**Subject: 2009 Slope Stability Analysis - Lakeview Rock Products Inc., Beck
Street Quarry, M0350020, Salt Lake & Davis Counties, Utah**

Answers and Responses to DOGM's Ninth Review of the Approved
Notice of Intention to Commence Large Mining Operations
Lakeview Rock Products, Inc.
Beck Street Quarry
M/035/0020
Comments Dated July, 26, 2010

Subject: DOGM Comments to Geotechnical Report, dated July 26, 2010

Plate
A-1

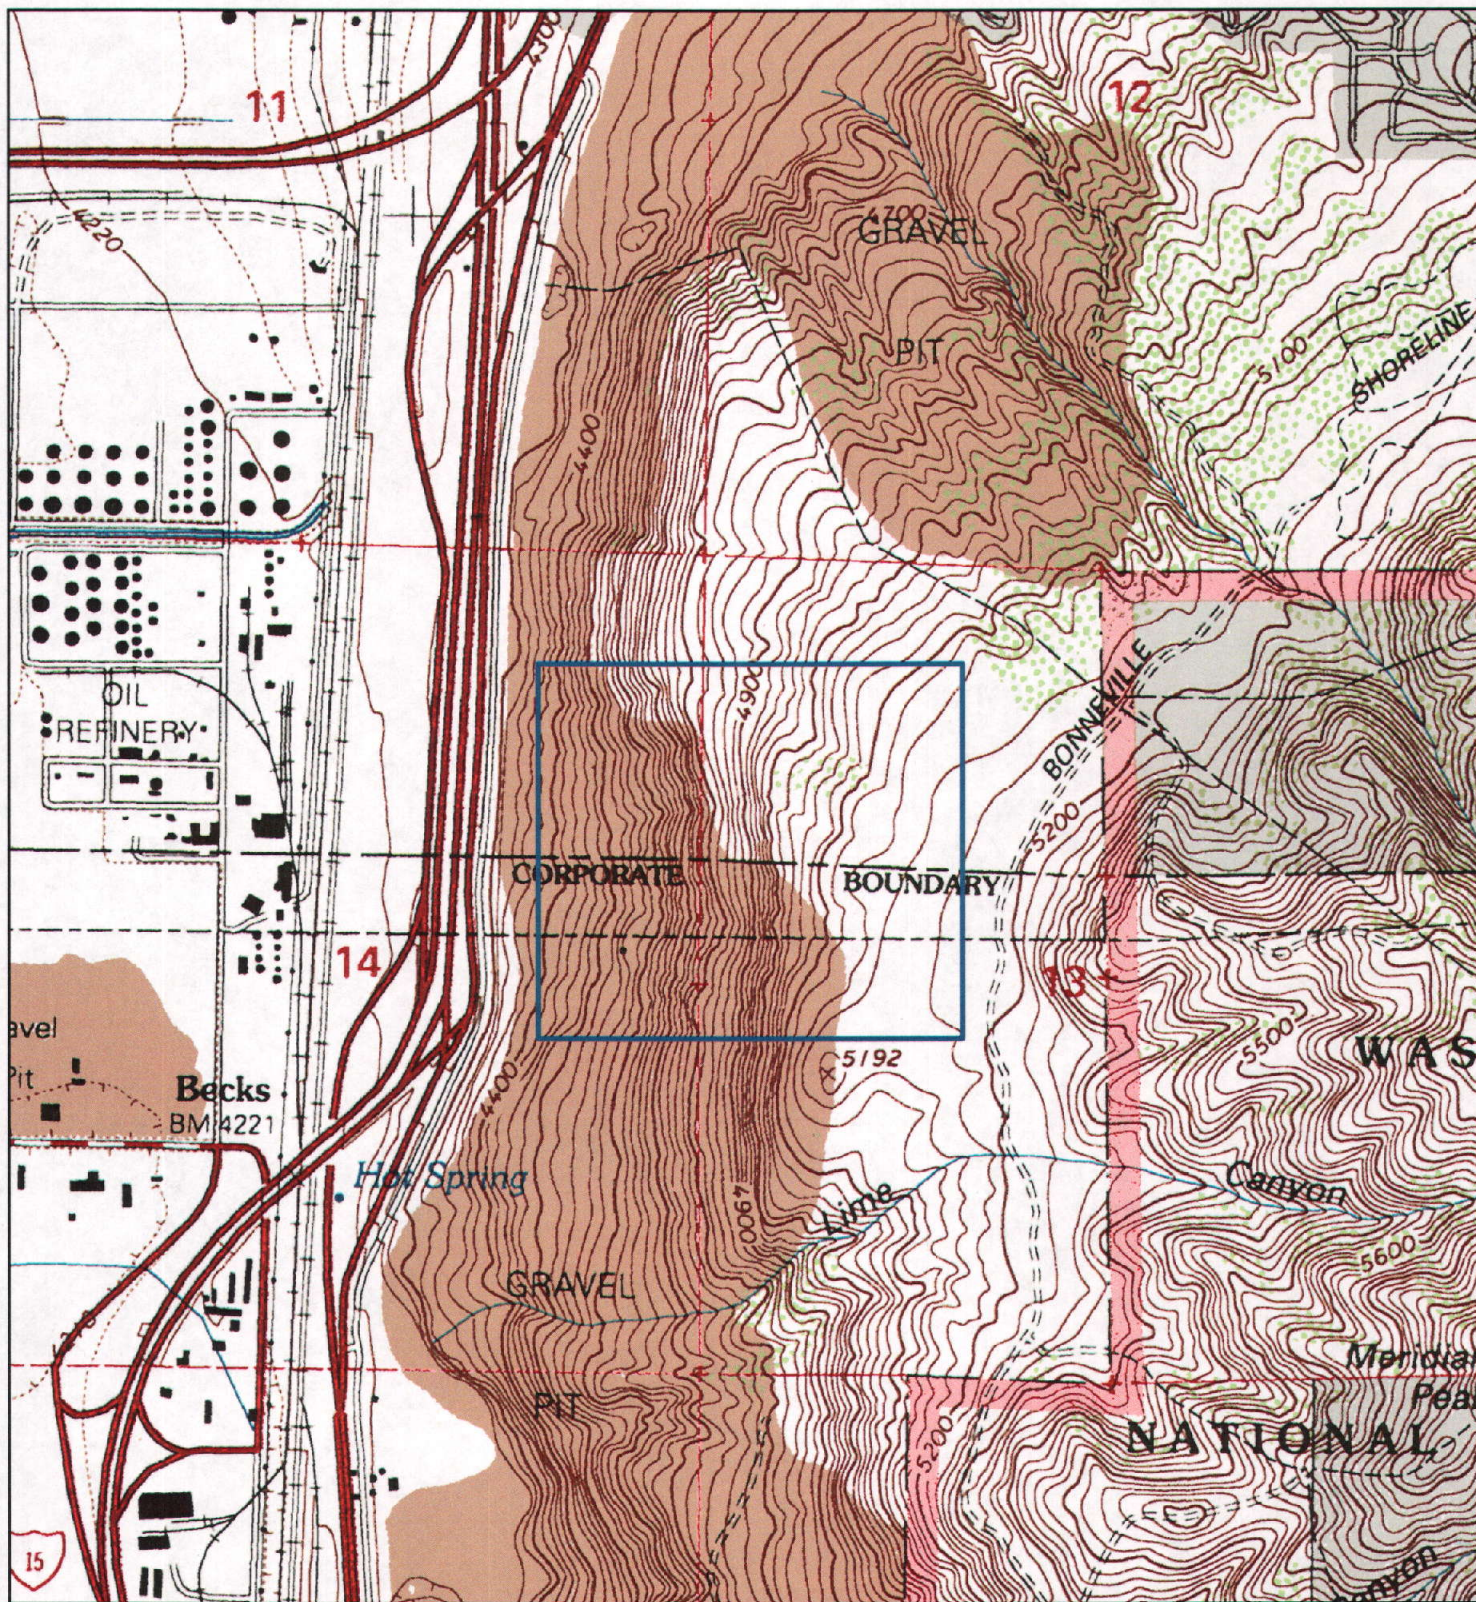
Comment #10: Slope stability report needs to include a geologic map, site vicinity map and the slope

stability cross sections map.

All of this information is included in the A appendix. The plates should have been a part of the original report. We have included them with this memo.

**Plate
B-1**

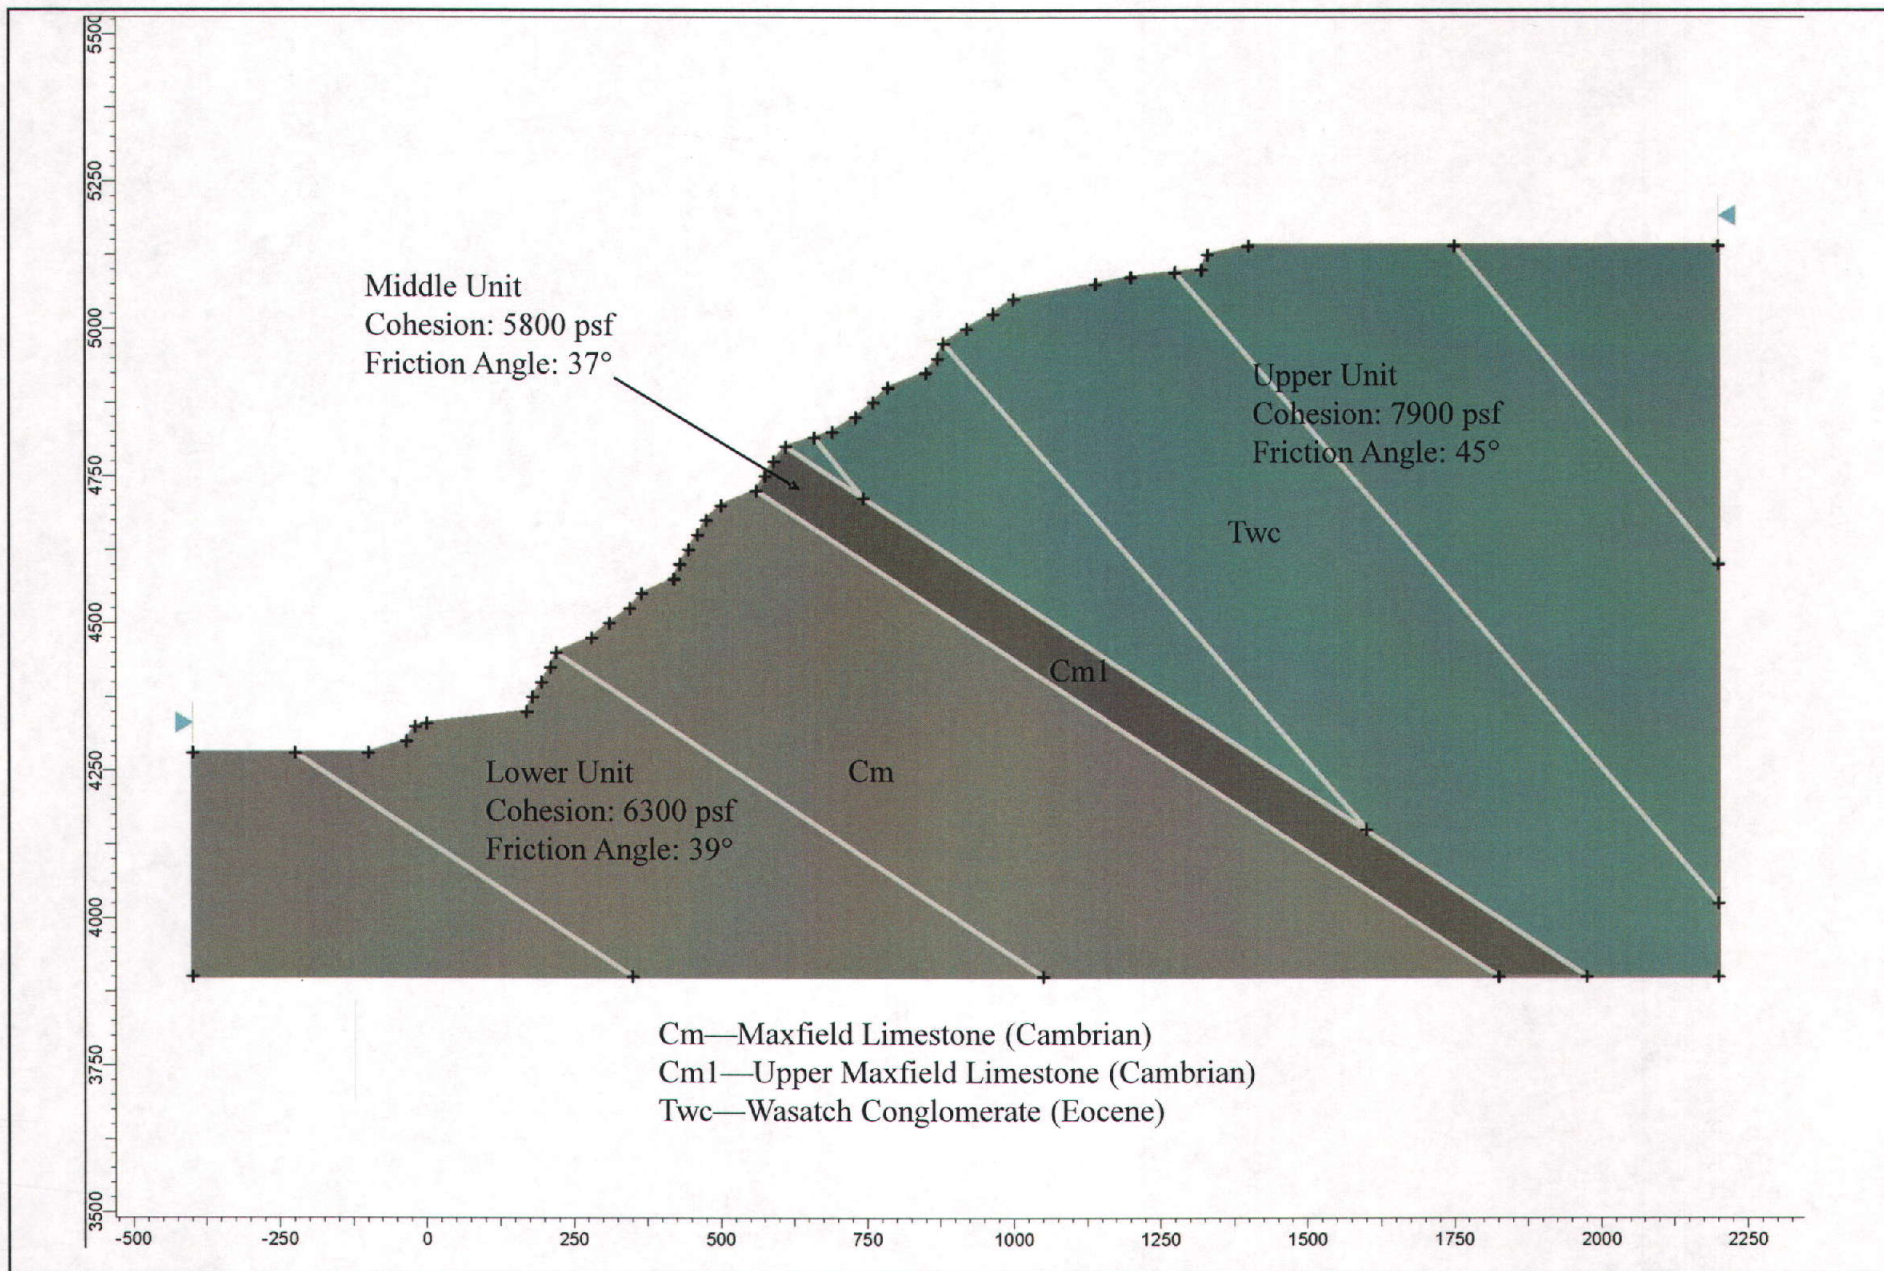
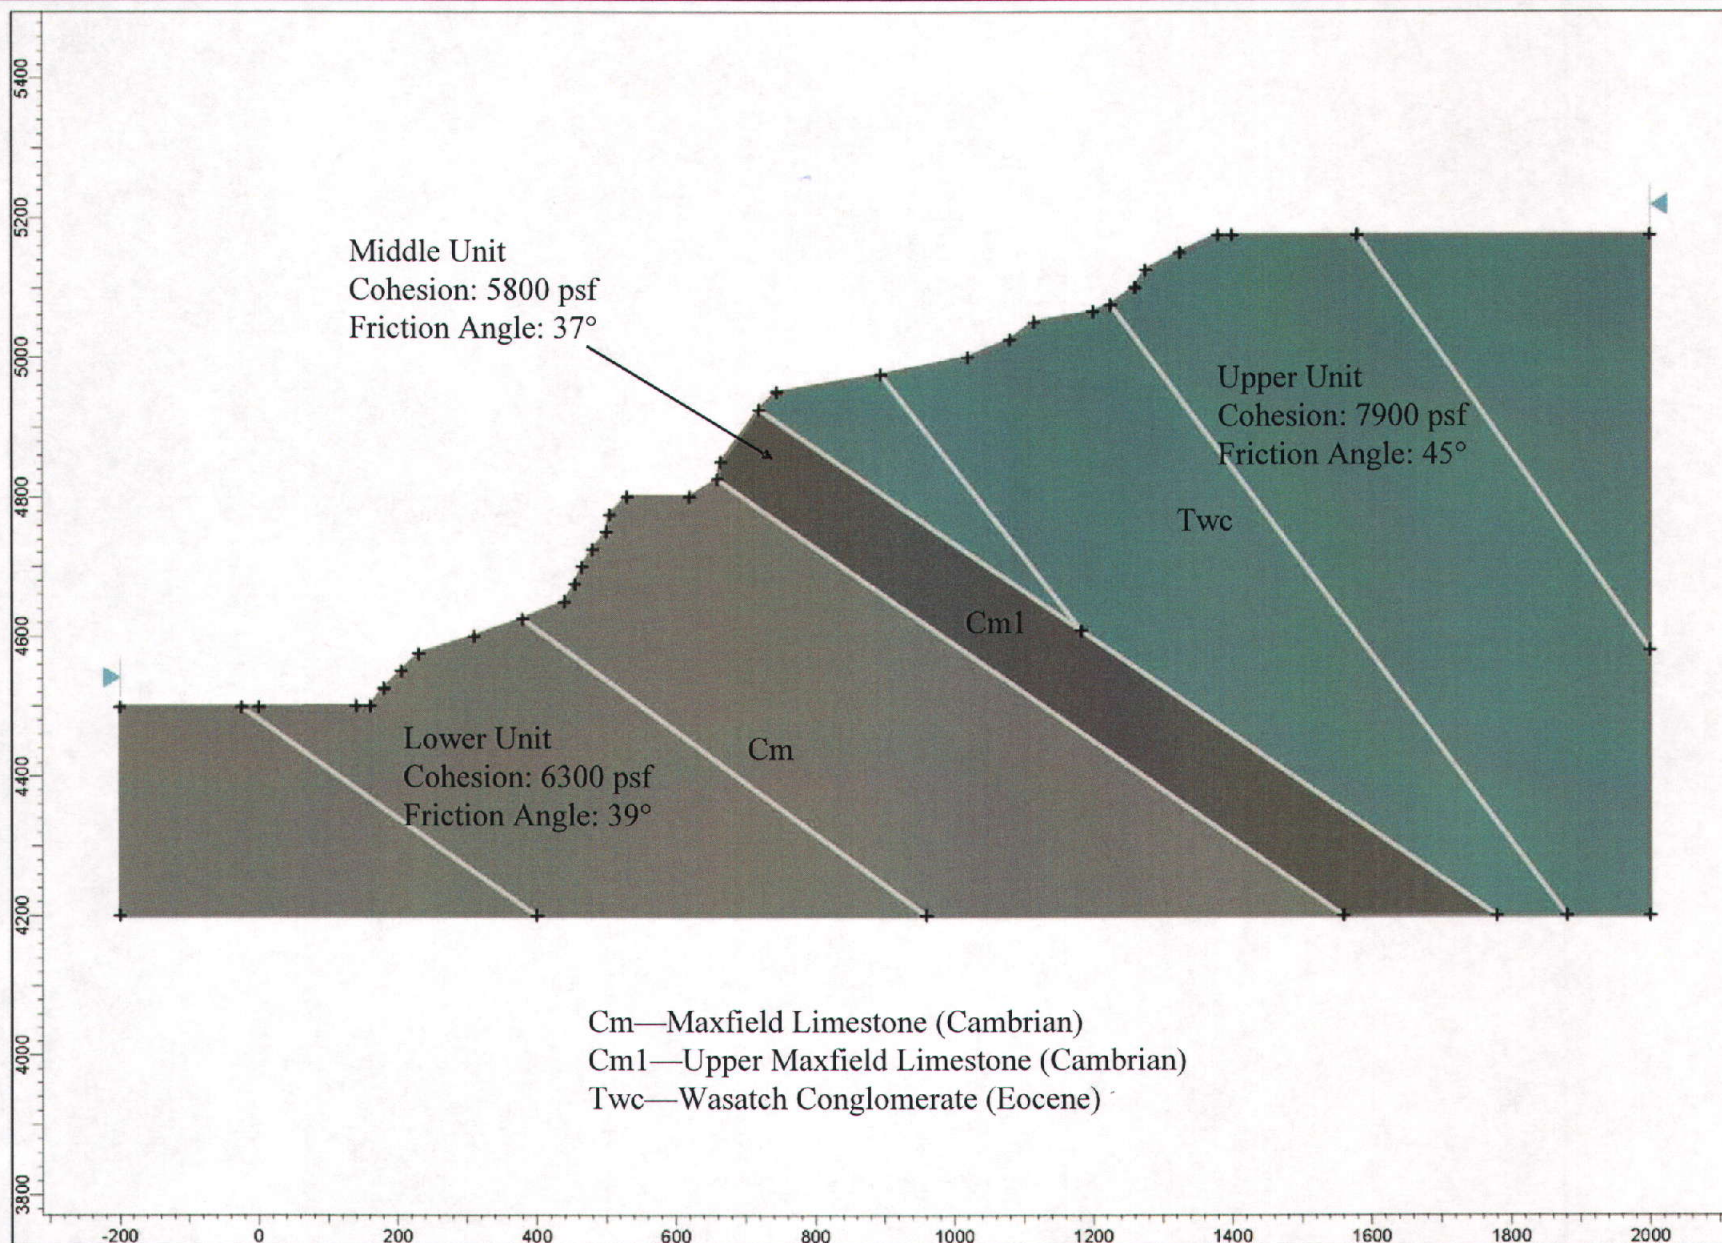
- 9 *Include the geotechnical model parameters of each lithologic unit as was done on plate B-1 and B-2 (this was comment 6 of the 8th review).*
See comments in GeoStrata response dated September 29, 2010. (attached)

Comment #9: Include the geotechnical model parameters of each lithologic unit as was done on plate B-1 and B-2.

The geologic model parameters are presented in Plates B-1 and B-2 for reference. The parameters do not change from model to model. Placing these parameters on each of the slope stability plates would be redundant, time consuming and costly.

**Plate
B-17**

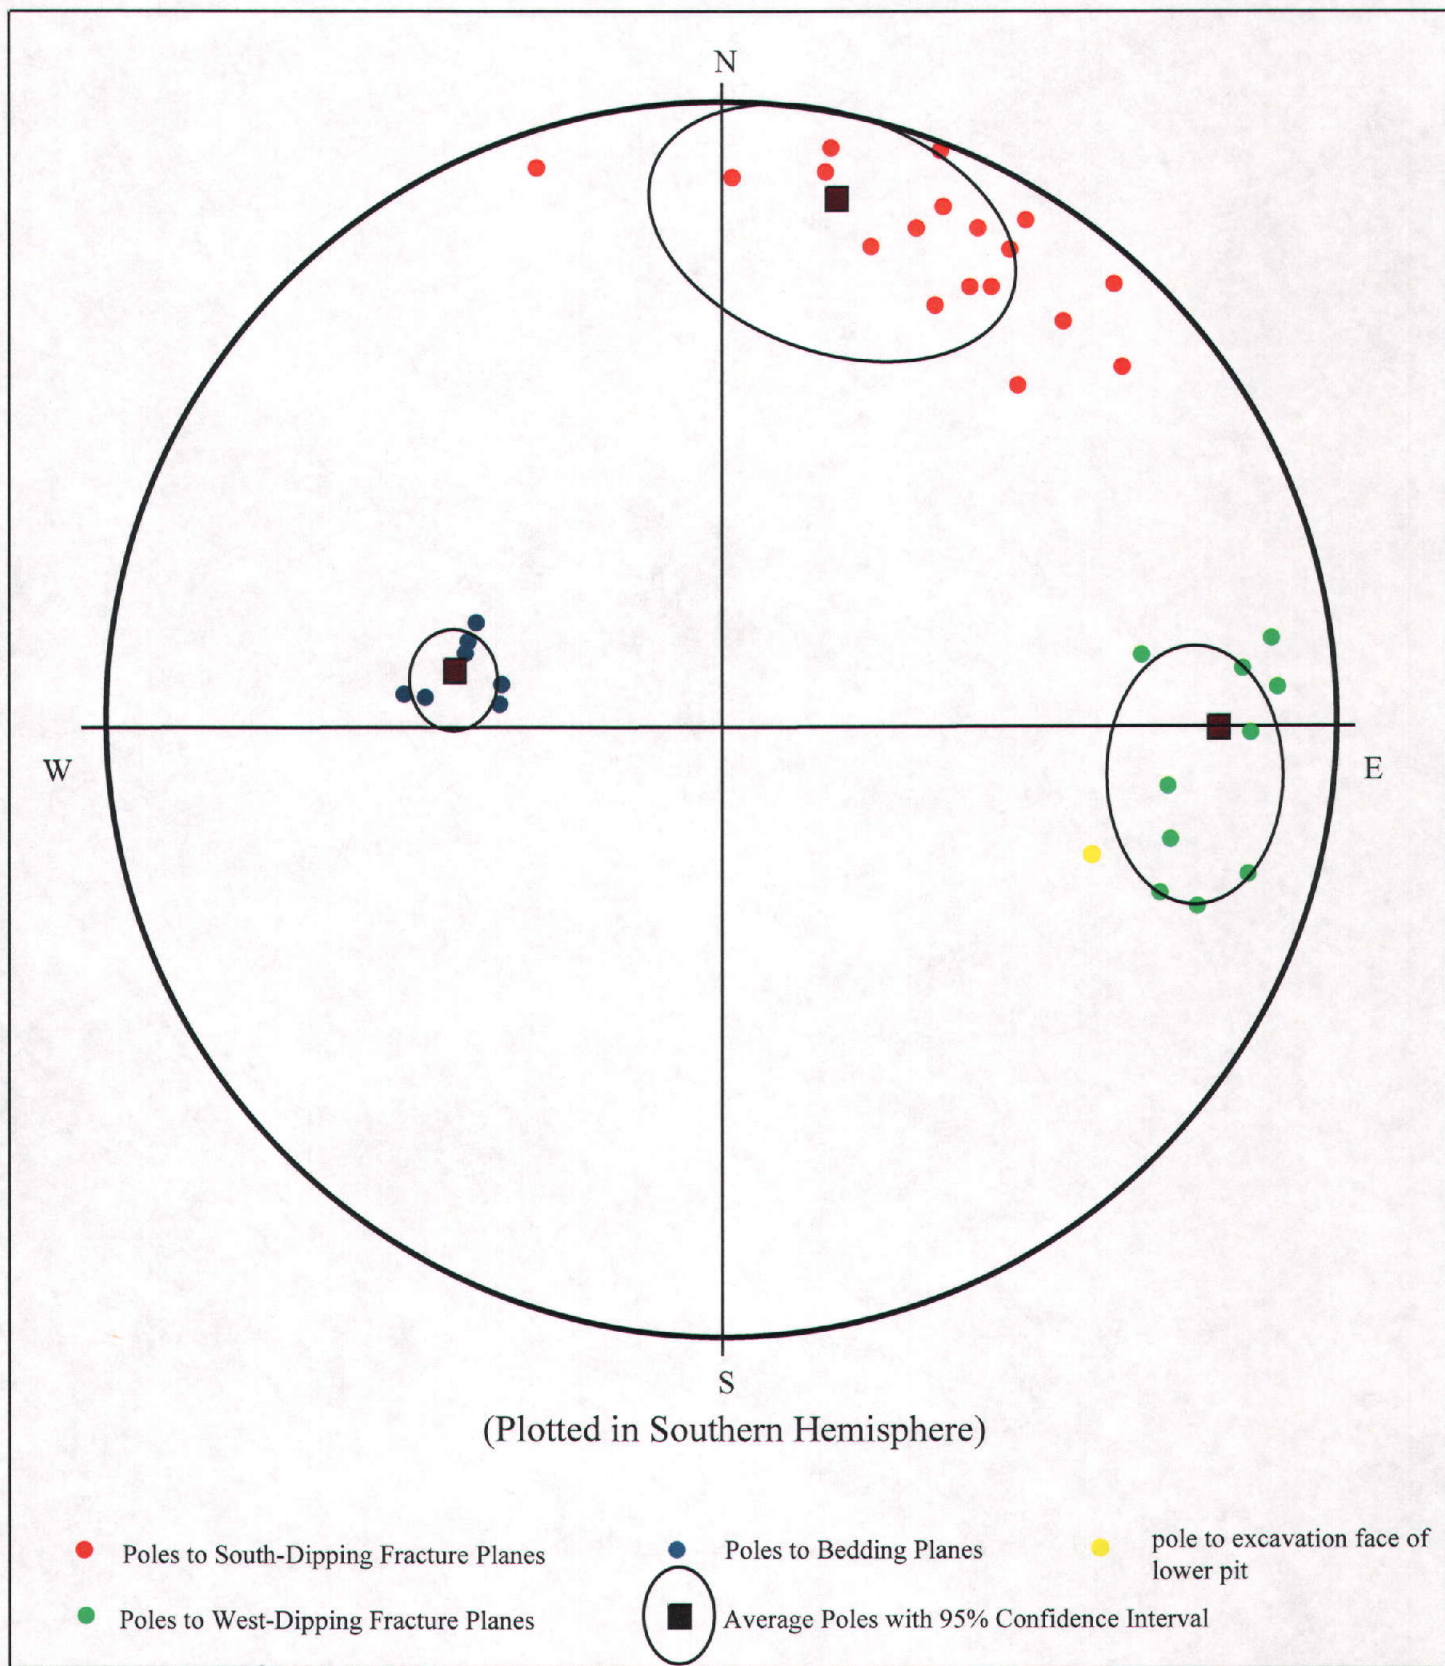
- 8 *Stereonet plot needs to indicate the excavation orientation plot in relation to the fractures and bedding planes. Label the lithologic units.*
See comments in GeoStrata response dated September 29, 2010. (attached)

Comment #8: Stereonet plot needs to indicate the excavation orientation plot in relation to the fractures and bedding planes. Label the lithologic units.

The plate has been modified as requested and is attached to this memo. Stereonets are representations of planes including joints, cut faces etc., they do not represent geologic units.
